# APPLICATION FOR PERMIT

APPLICATION FOR PERMIT

Memorandum from Department of Building Inspection, Portland, Maine

Ryefield Street, Peaks Island (Charles Franco)—Alteration of open rear  
piazza for and by Mr. Franco—10/7/50

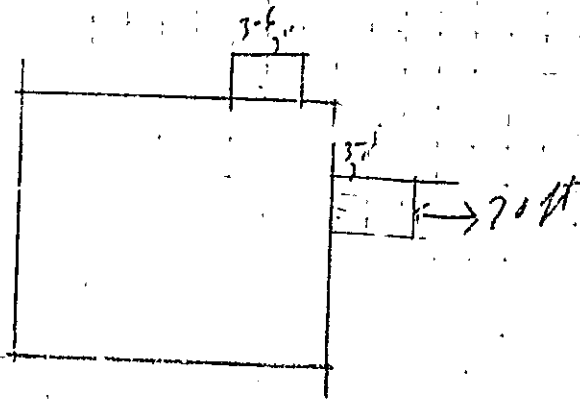
Please note that check of this job against the Building Code has been made using the data filed by the owner on the application for the permit, and that data should be closely followed unless otherwise indicated below or unless this office is consulted to make sure the change complies with the requirements.

Note that the 4x6 sill indicated on the application is required to be solid lumber in cross section, not built up of two 2x6's, and would normally be set with the 6" dimension upright and lap splices used at the corner piers.

The floor joists are either to be supported upon the top edge of the sills or upon no less than 2x3 nailing strips spiked to the inside face of the sills, the floor joists if necessary being notched over the nailing strips. The 2x6 floor joists indicated on application are larger than required by the Building Code. They may be used of course, but the Building Code would allow 2x4's not more than 18" from center to center with the 4" dimension upright.
